Architect / Originator: Tate Harmer Client: Platinum Land		Unit G182, Stamford Works, 3 Gilett Street, London N16 6JH Tel: +44 (0)20 241 7481 Email: sales@stamam.com		Do not scale. All dimensions to be checked on site. This drawing is copyright.	
Project: Bolshe Park Firestation		8 Quorn House, 1 Duke of York Square, Kings Road, London, SW3 4LY		Date of Origin: 28.11.17	
Drawing Title: Proposed Roof Plan				Drawn By: ABF	
Drawing Number: BFS THA PR PA 140 P2		Revision:		Drawing Status: Planting

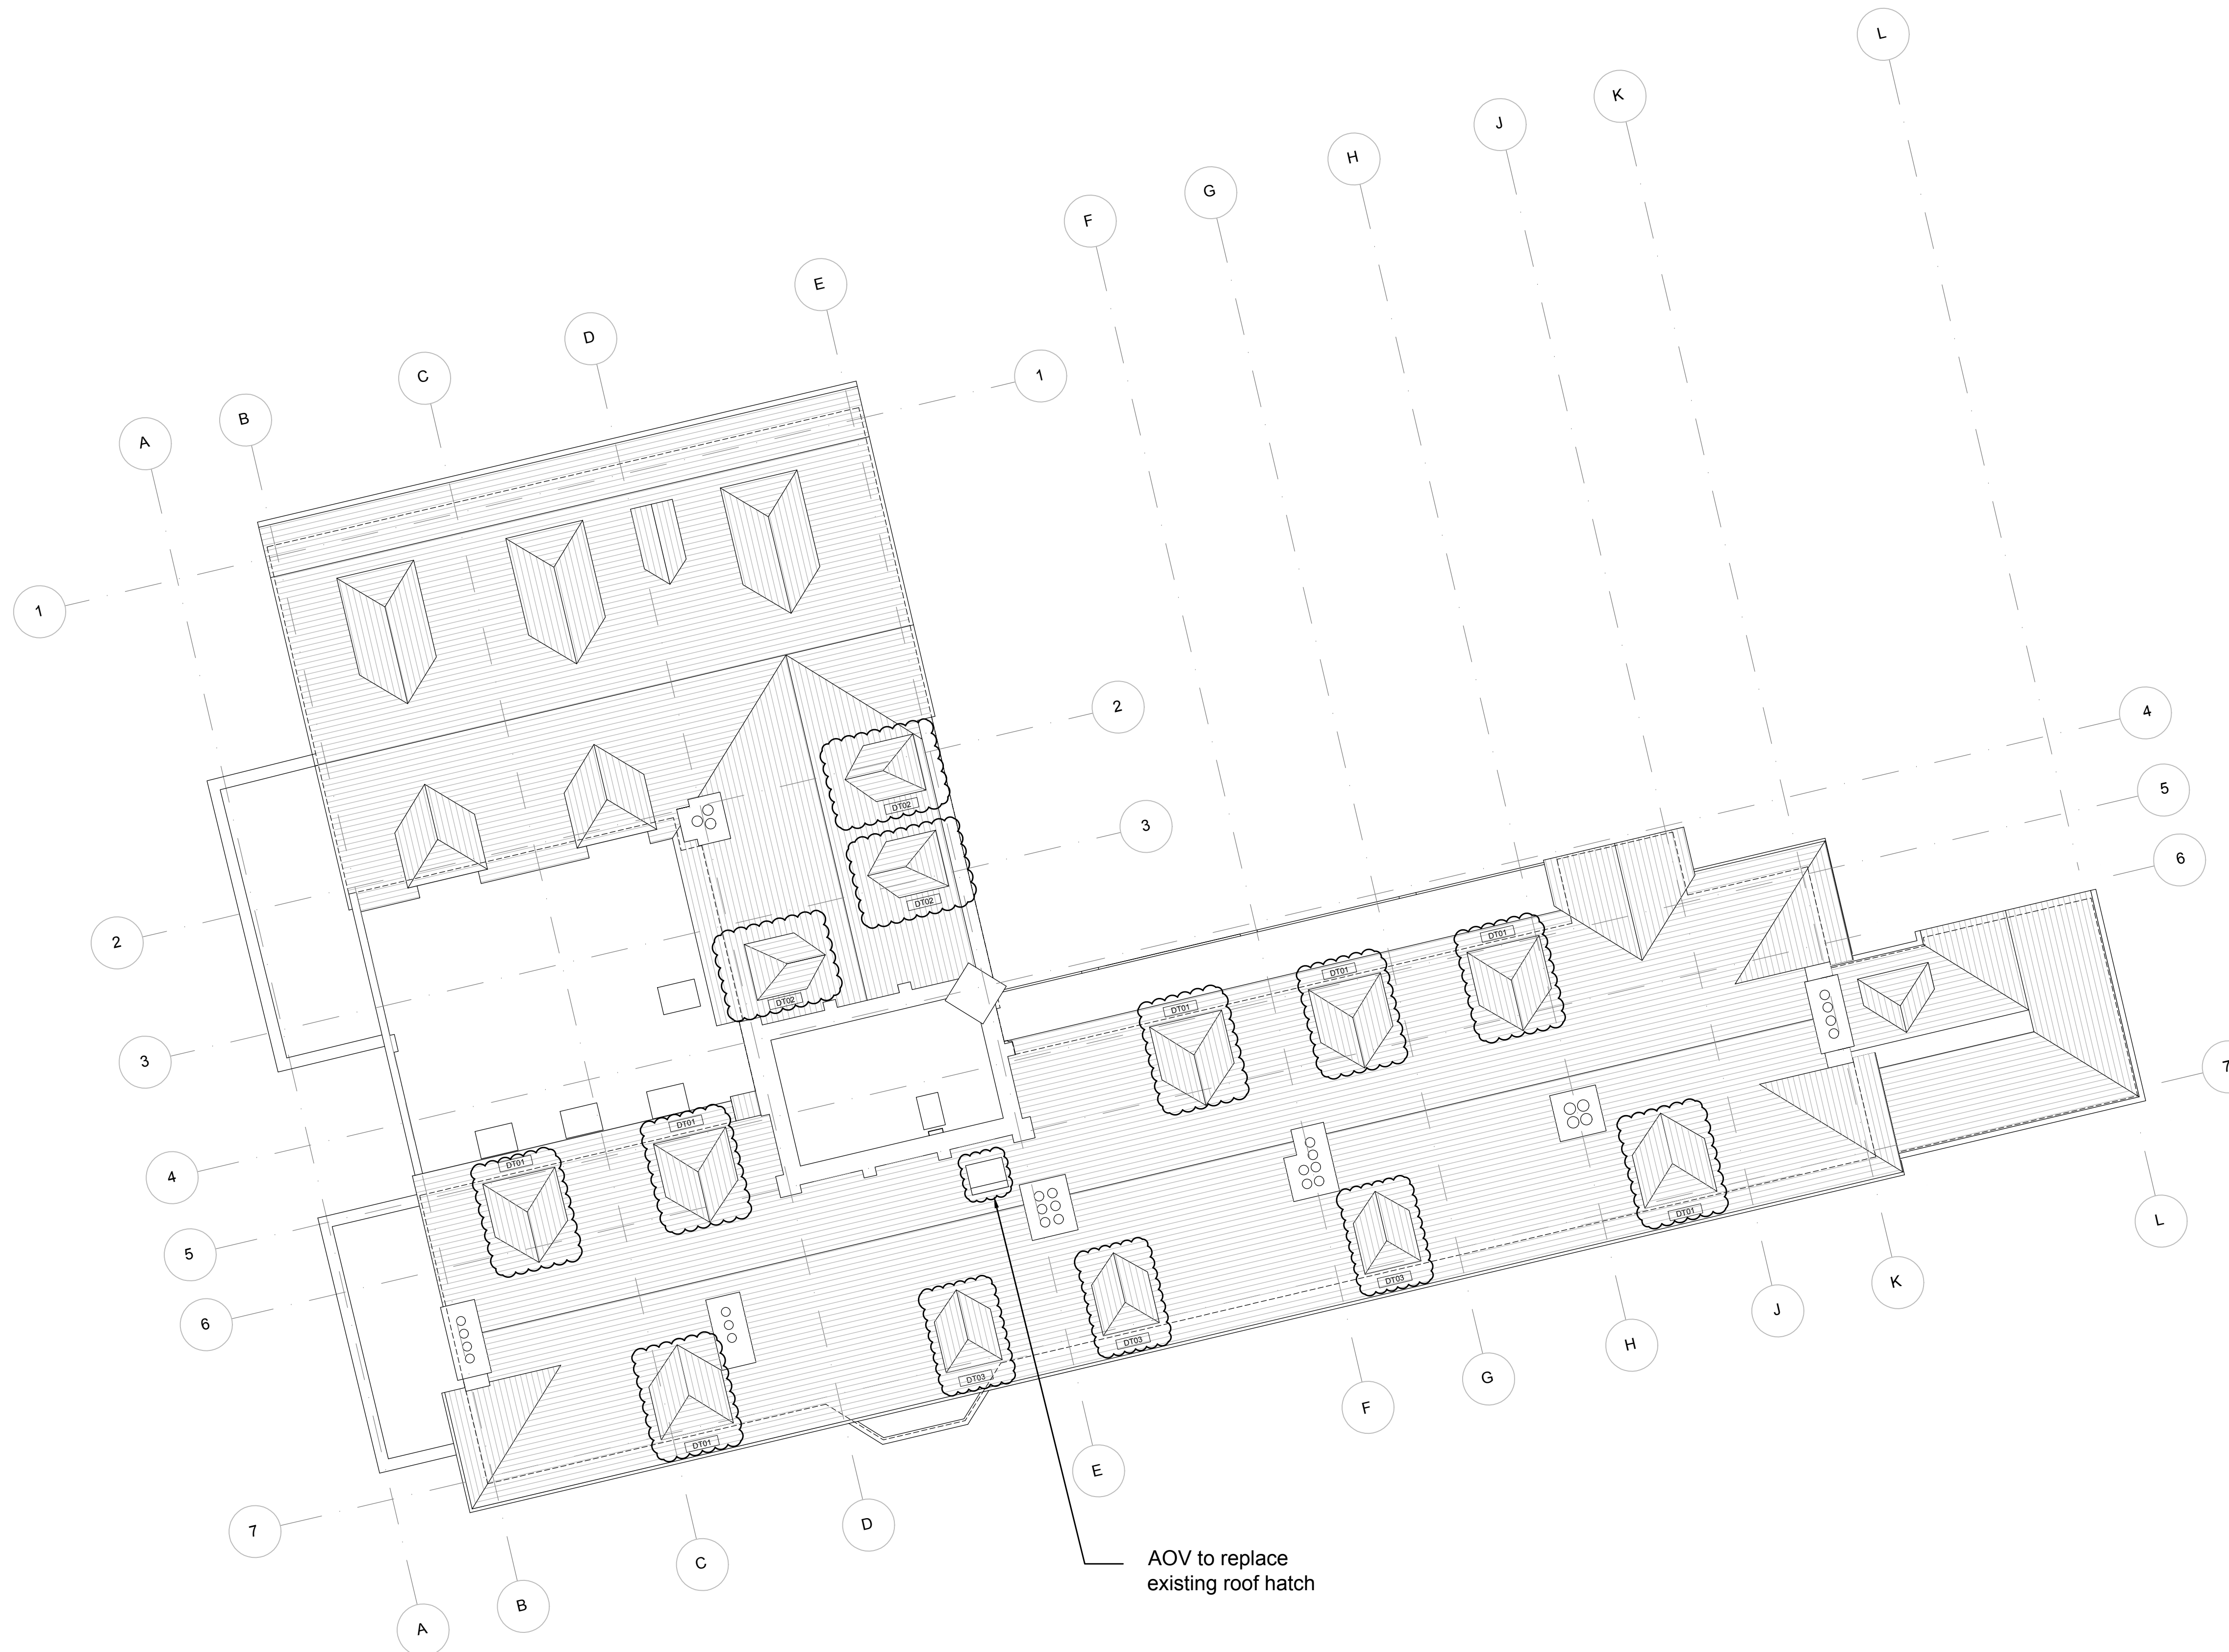
- AOV to replace existing roof access hatch.
- Dormer cheeks made to match dimensions as per existing dormer windows in courtyard.

AOV to replace
existing roof hatch
